RE: Lissau Property, Lot 3, B02429836
600 Tower Bank Court, Severna Park, MD 21146
TM 31 BLK 11 P 360, R-1 Zoning, Council District 5

On behalf of the property owner, I am submitting a variance application for the above-referenced project. The property owner is proposing to demolish an existing carport and shed to allow for the construction of and new carport and shed with a similar location. This proposal will require a variance to allow development within the expanded buffer to tidal waters. Although this is not a waterfront property, the 100' buffer to tidal waters gets expanded to include steep slopes and a 50' buffer to the top of steep slopes. The expansion of the 100' buffer pushes the buffer to encompass the entire property. Since this is the case there is no way to develop the property without the need for a variance.

OFFICE OF PLANNING AND ZONING

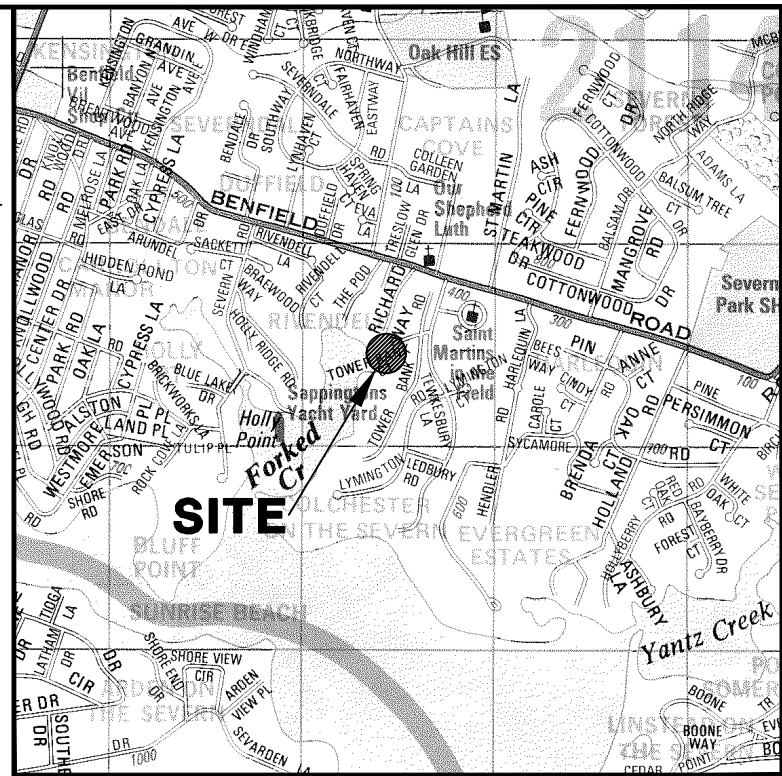
The site plan will need to dimension the distance between the proposed addition and the corner side lot line so a variance distance can be determined. The existing dwelling height and addition height should be clearly labeled on the site plan. The applicant should provide additional justification on why the size of the carport is being increased and how this increased size represents the minimum necessary.

Our response: Noted
